# ADDENDUM

**ADDENDUM NO.:** 001  
**PROJECT NAME:** CANTY ELEMENTARY SCHOOL ANNEX  
**PROJECT NO.:** 05750  
**CONTRACT NO.:** C1568  
**DATE OF ISSUE:** May 28, 2015

## NOTICE OF CHANGES, MODIFICATIONS, OR CLARIFICATIONS TO CONTRACT DOCUMENTS

Sheet  
**S-103**

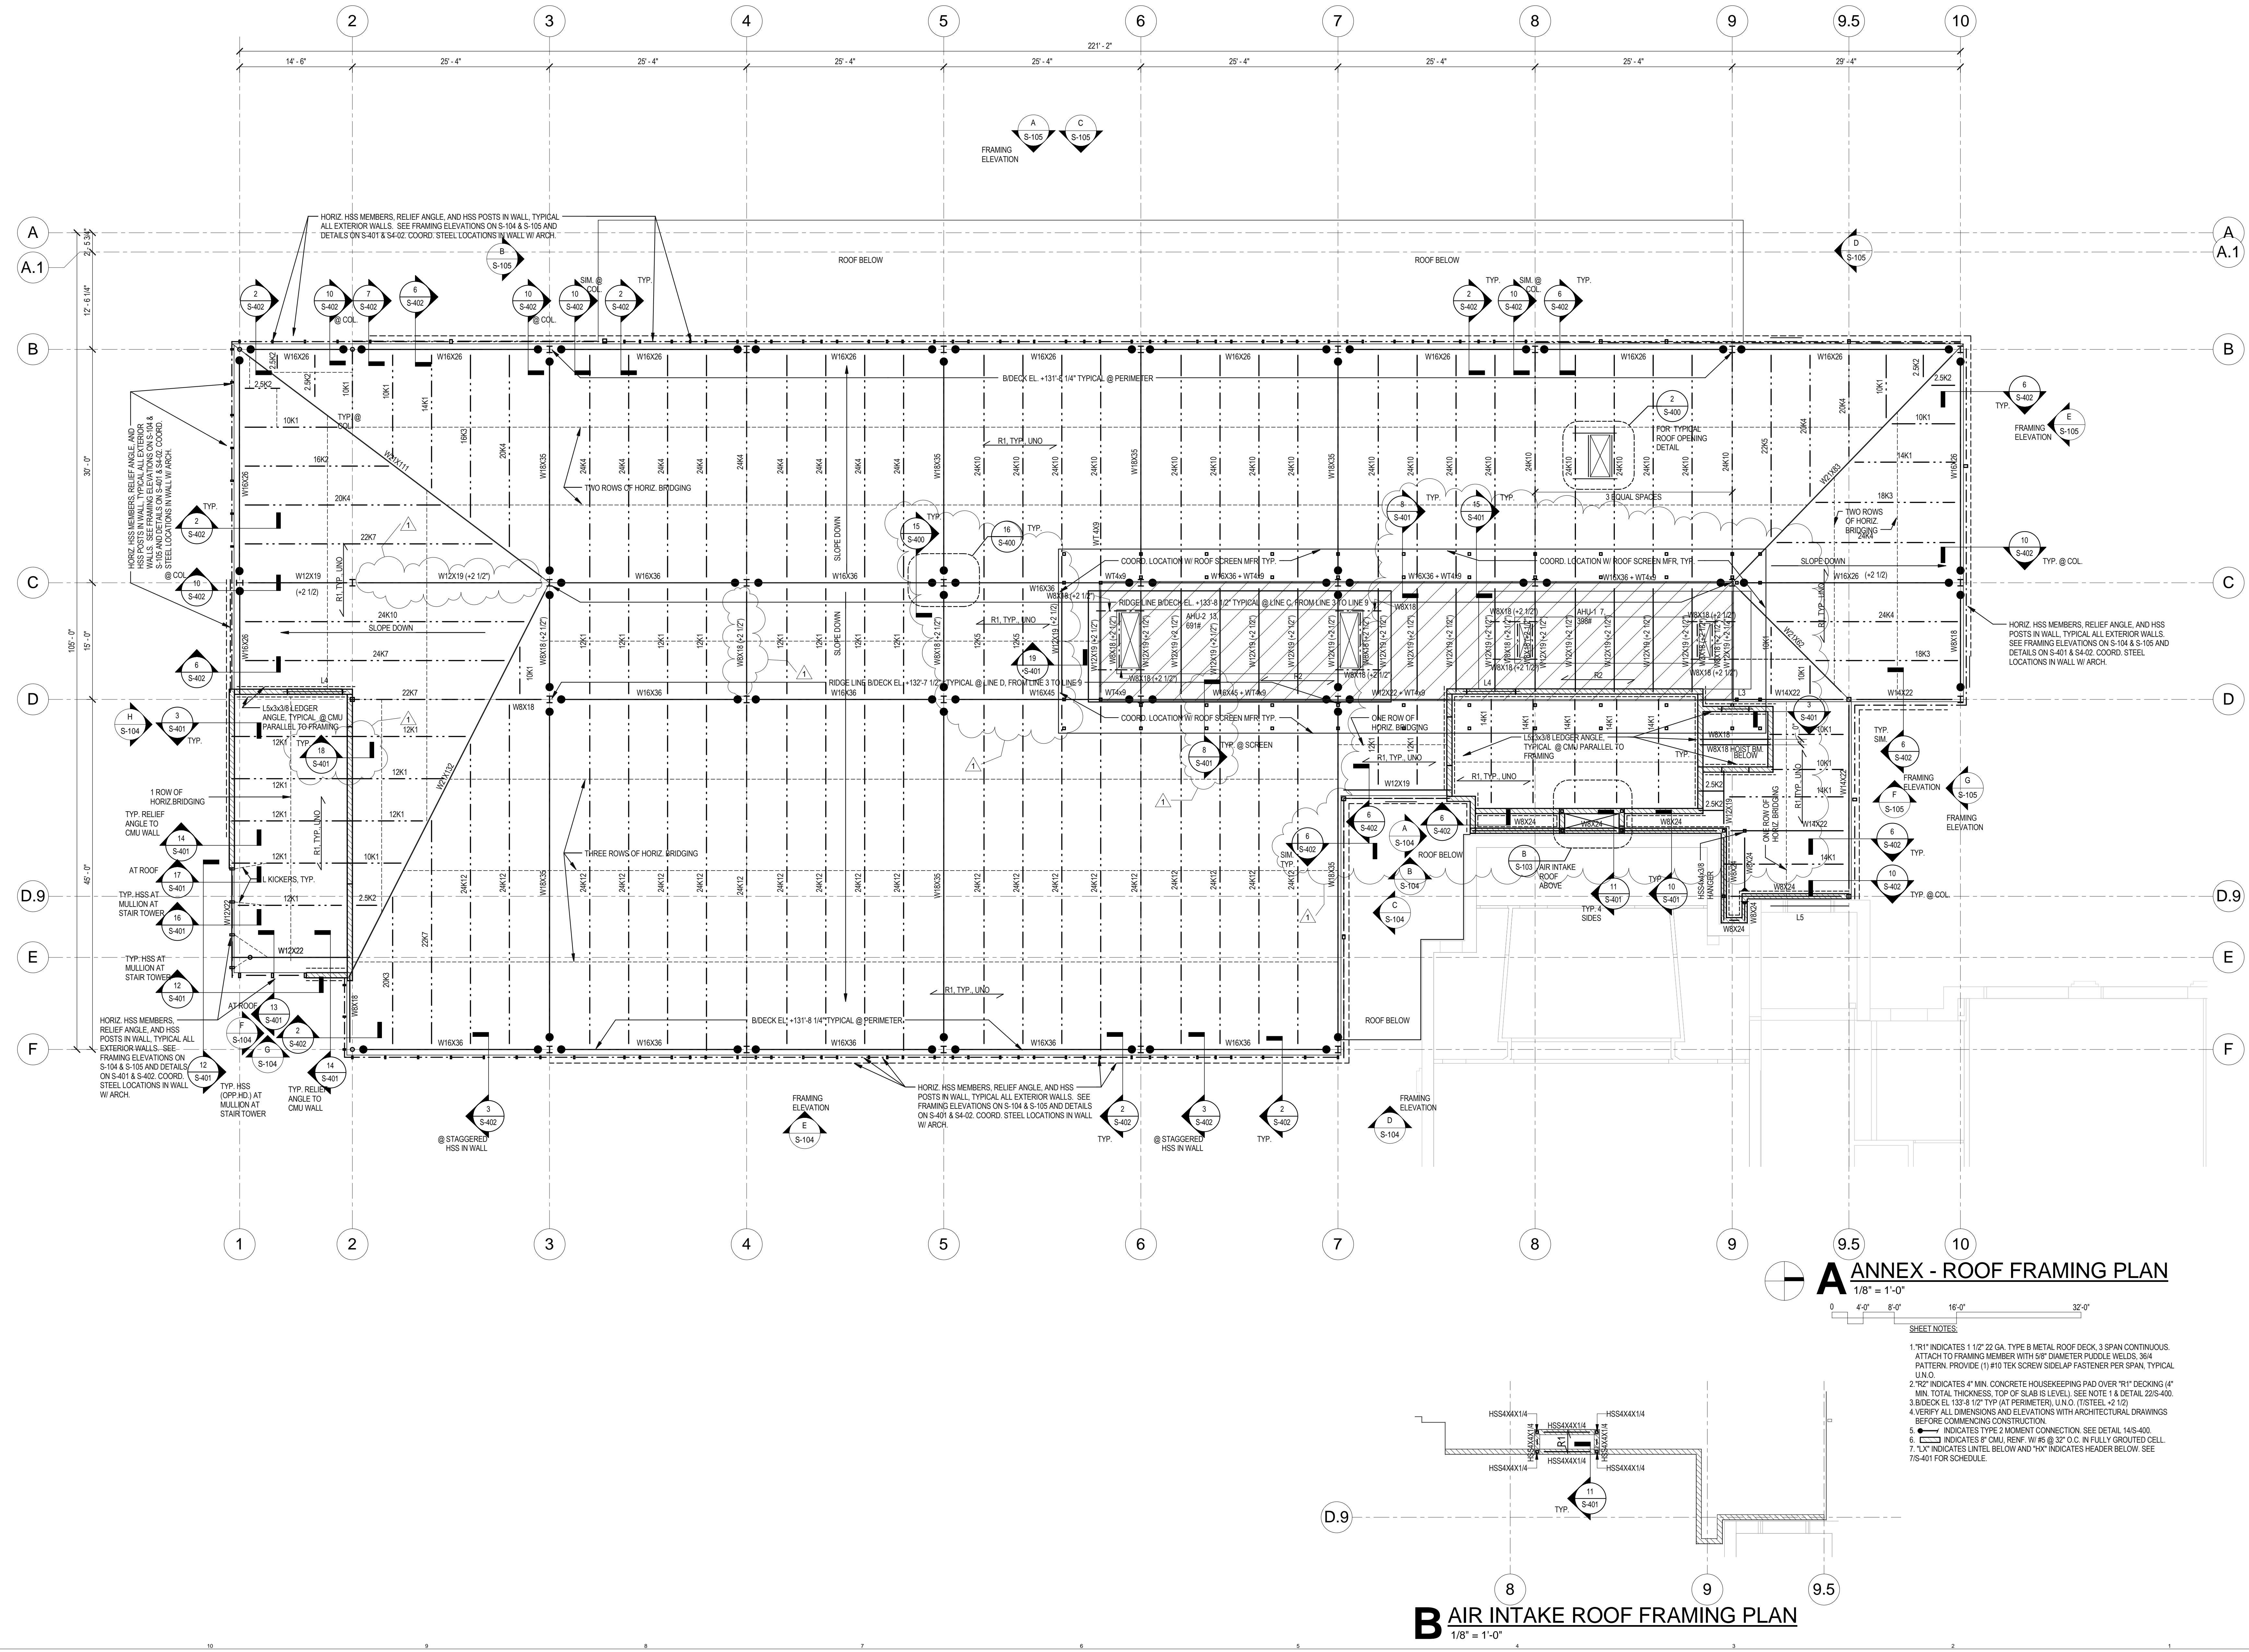
- 1. Sheet S-102 Annex Second Floor Framing Plan
  - a. Missing section marks provided.
  - b. Penetrations for risers to coordinate with MEP drawings indicated.
- 2. Sheet S-103 Roof Framing Plan
  - a. Missing section marks provided.
  - b. Top of steel elevations provided. WT4x9s added at mechanical penthouse
- 3. Sheet S-401 Framing Details
  - a. Details 15 and 19: WT removed, WF moved up 2 ½".
